**APP-GW-GLY-089 Revision 0
MCR Dose, Hydrogen Venting, PMS Flux Doubling, and MCR
Heat Up Open Session ACRS Presentation
Non-Proprietary**

Hydrogen Venting Inside Containment

PXS-A Compartment (Room 11206) Vents

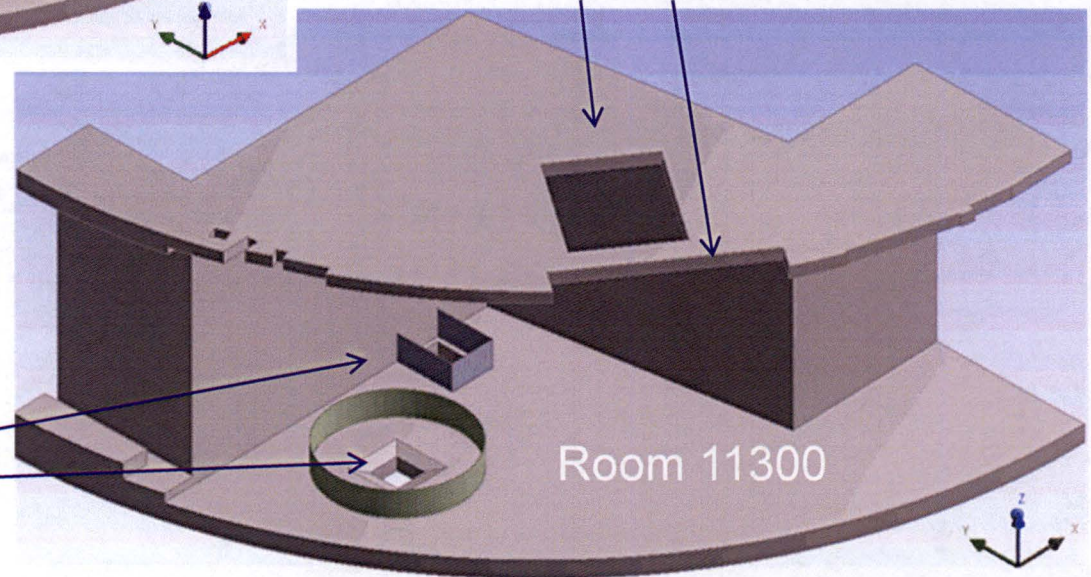
- AP1000 design changes to containment layout were implemented without revision to supporting analyses for hydrogen diffusion flame
- In one particular severe accident scenario (frequency = $6E-9/\text{yr}$), a hydrogen diffusion flame may create a locally high temperature near containment pressure boundary, hatch and penetrations
 - Analysis required to verify a containment survivability
 - ITAAC revision is required to reflect containment layout design changes

<- Original layout

Final layout ->

Vents in Ceiling of 11300
to Upper Compartment

- Revised ITAAC (Tier 1 Table 2.3.9-3)
 - Updated the minimum distances requirement between openings and the containment shell to reflect the actual geometry, including tolerances
- Supporting Subsections 6.2.4.5.1 and Section 19.41.7 also updated.
